Service Kit 37040-0000

TOILET SERVICE KIT – UPGRADE NOTICE

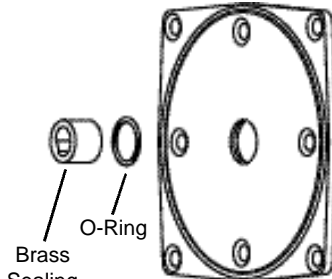
This Service Kit contains a new Up-Graded Plastic Wearplate with improved Waste Pump and Rinse Water Pump Shaft Seal. This new seal provides better fluid separation between the Centrifugal Waste Pump and Flexible Impeller Rinse Water Pump.

The new Wearplate Kit supercedes the old Brass Wearplate and its associated Brass Sealing Sleeve and O-Ring. It also supercedes early Plastic Wearplates with

1/2" ID Counterbore around the shaft hole and its associated small flat Rubber Sealing Sleeve. The new Wearplate eliminates the need for the thin Stainless Steel Wearplate and a second Paper Gasket required with this Wearplate. It uses a Square Section O-Ring to seal the pump assembly to the Toilet Base, eliminating the need for the Square Rubber Gasket with 3" round center hole used on very early toilet production.
